**From:** Hack Conder [hconder@riceswd.com]  
**Sent:** Thursday, May 27, 2010 3:11 PM  
**To:** Hansen, Edward J., EMNRD  
**Cc:** Katie Jones  
**Subject:** NMOCD 1R-27 (BD A-27 addendum2)  
**Attachments:** figure eight.jpg

I am requesting a addendum to the Corrective action Plan for NMOCD 1R-27 (BD A-27) dated May 24, 2006. I would like to include in paragraph two under section Recommendation for Corrective Actions the following.

## BD A-27 leak

**CORRECTIVE ACTION PLAN**  
**RICE Operating Company**  
**BD A-27 Release Site**  
**T22S-R37E-Section 27, Unit Letter A**  
**Lea County, New Mexico**

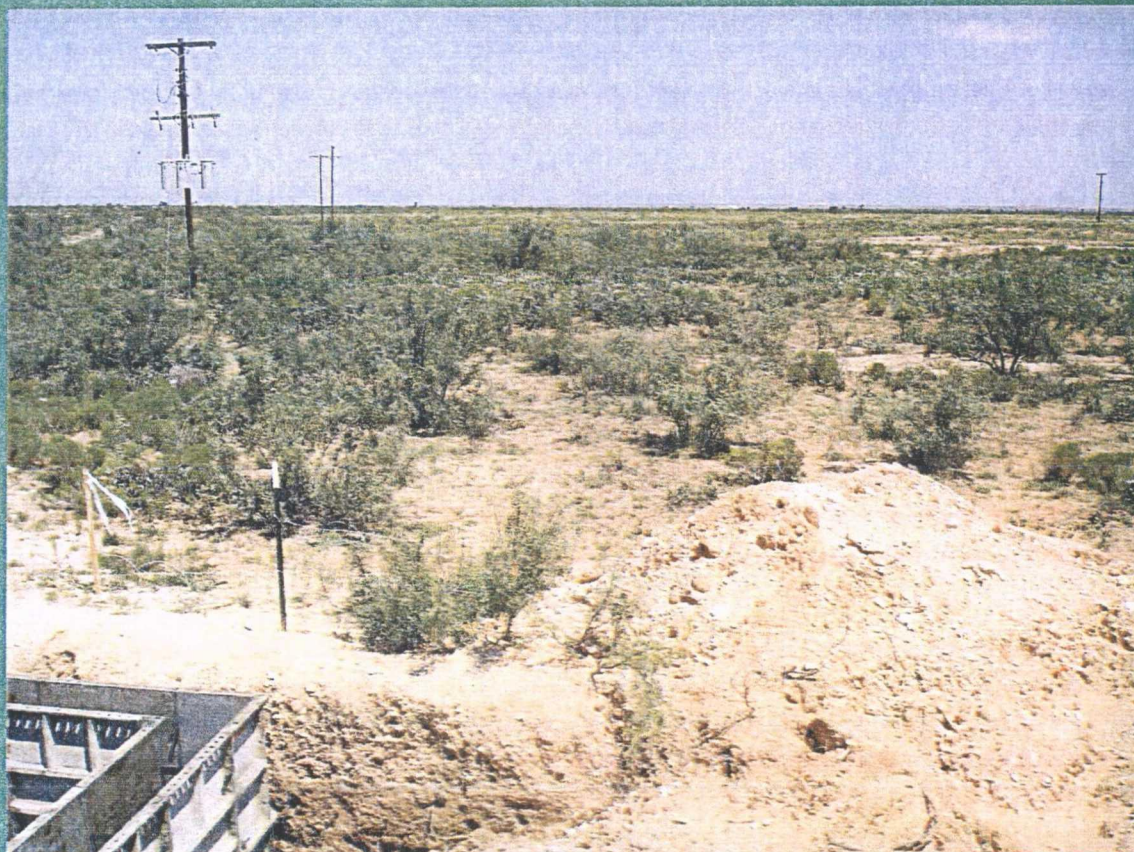
Perform surface water management in three areas identified on attached figure eight( 1 to 2 feet burmed areas) .Drill one confirmatory boring between soil bore 5 and soil bore 7 to minimum depth of 30 feet also shown in figure eight . The criteria to delineate in the soil boring is after three consecutive samples showing a decreasing trend of chloride (Samples taken in 5 feet intervals) and the last sample shows chloride < 250 ppm.
